PLANNING COMMISSION REPORT
Regular Agenda – Public Hearing Item

**ITEM NO. 2 SPECIAL USE PERMIT FOR LAKE VIEW VILLAS @ ALVAMAR; 2250
LAKE POINTE DR (SLD)**

SUP-15-00065: Consider a Special Use Permit for Lake View Villas @ Alvamar, a residential development including 11 existing four-plex buildings, 8 proposed duplex buildings and 24 detached dwelling units on approximately 16 acres, located at 2250 Lake Pointe Dr. Submitted by CFS Engineers, for CornerBank, property owner of record.

Table 1: Approved and Proposed SE area development

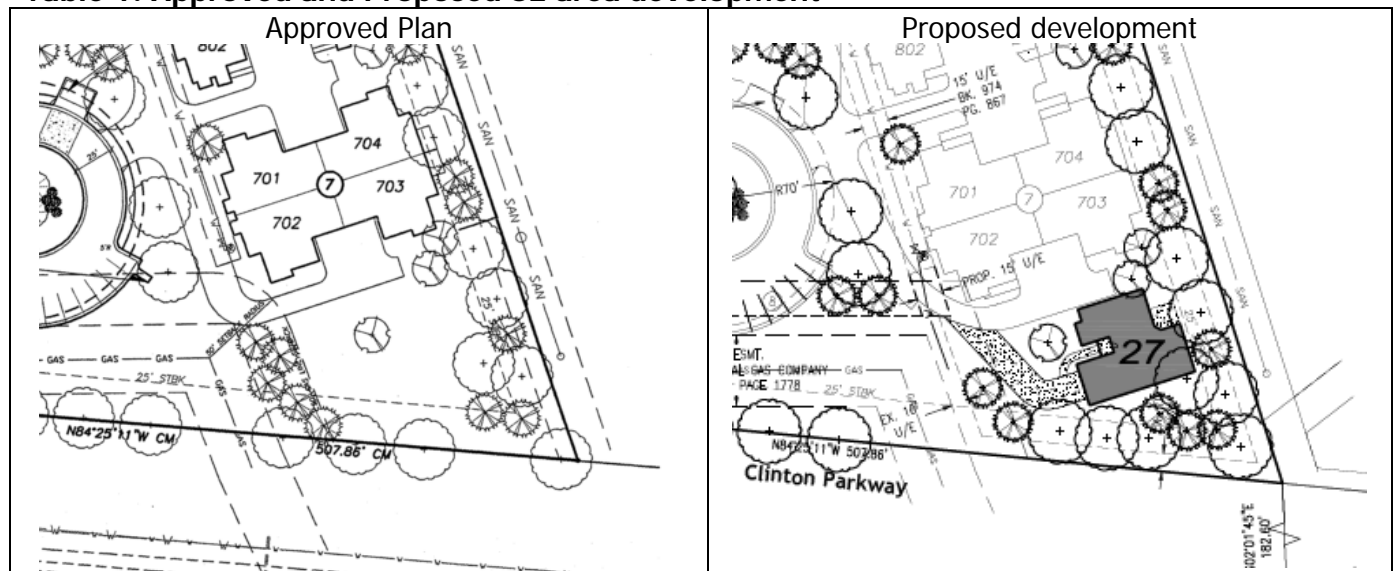
The revised plan adds a dwelling unit in the southeast corner of the site. The approved plan showed this area as open space.

Figure 2: Typical Off Street Parking for Duplex

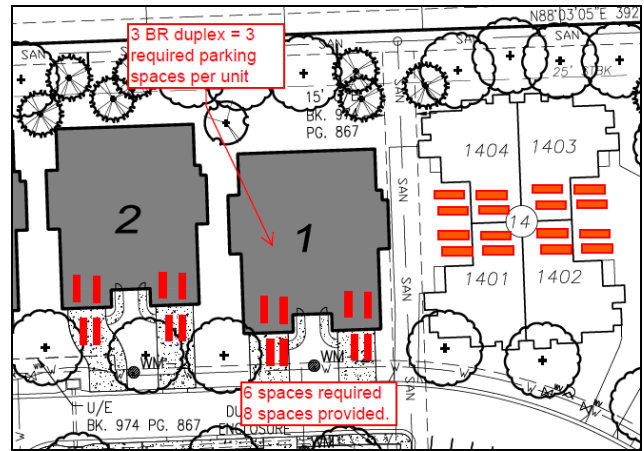
This project was always designed with excess parking by providing double car garages and double wide pavement. A unit with only three bedrooms (one space per bedroom would require only 3 parking spaces. However the larger 4-plex units typically include four total parking spaces, two in the garage and two in the driveway. This excess parking is compounded throughout the development. Double car garages are typical features of low density residential development. The following image depicts a proposed 3 bedroom duplex (6 total bedrooms in two units) with an attached garage and driveway parking.

Figure 3: Access options

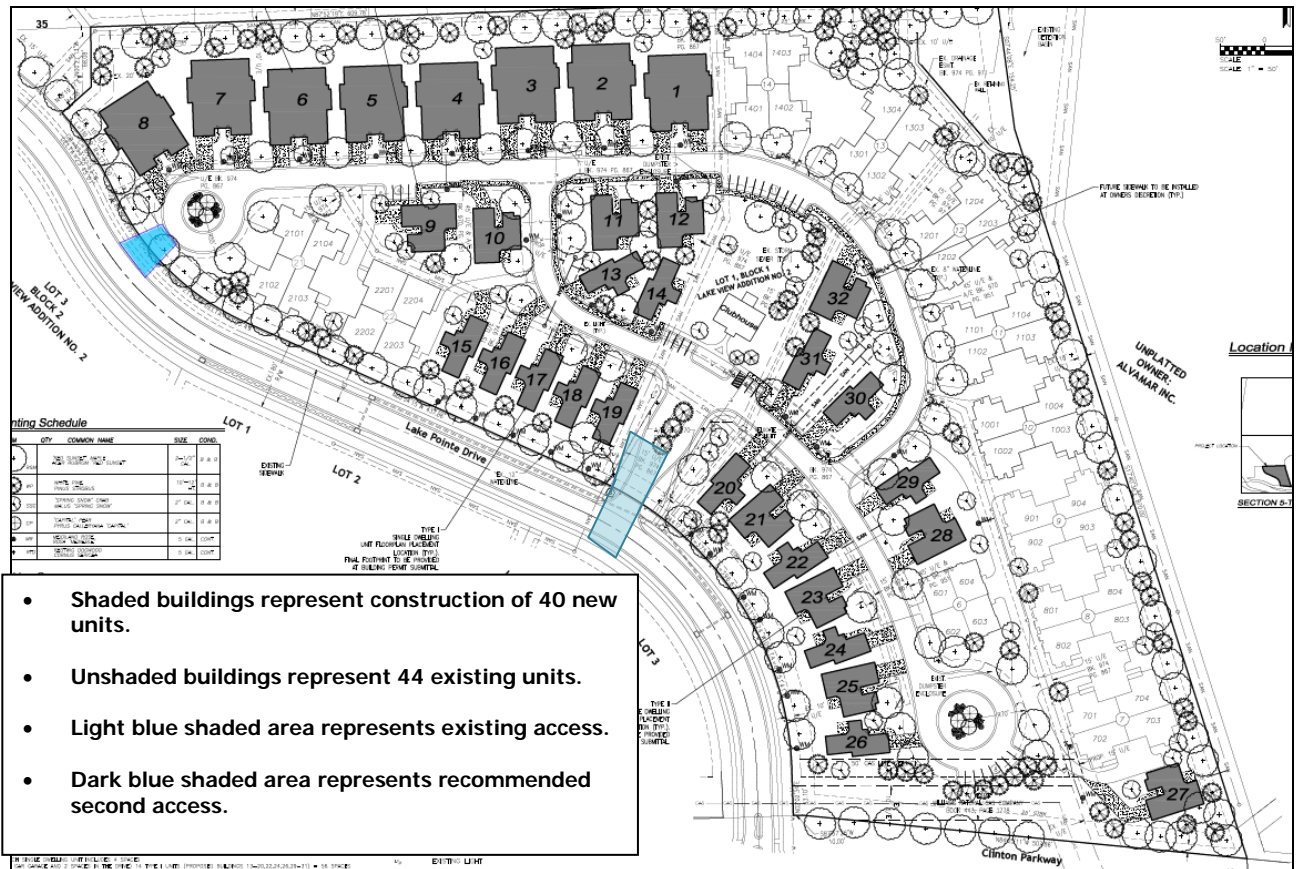
Access: Access to this site is provided via a single driveway intersecting with Lake Pointe Drive, a local street. There is no other direct access point to this property. New development that included 30 or more dwelling units would require a second access. The applicant notes that this request reduces the total number of dwelling units from the approved 2006 plan. A second access could be provided at the north end of the development by extending a driveway from the interior access drive to Lake Pointe Drive.

It is notable that Access in this area may be altered as KDOT develops plans for the K-10 highway improvements. A concept plan is included as an attachment to show how the overall access to this area may be affected in the future.

Staff recommends as a condition of approval that the plan be revised to provide a second access to Lake Pointe Drive in the northwest corner of the site. This access may be designed for emergency access only and does not require full public access to the development. The access must be designed to accommodate emergency apparatus and maintained year round.
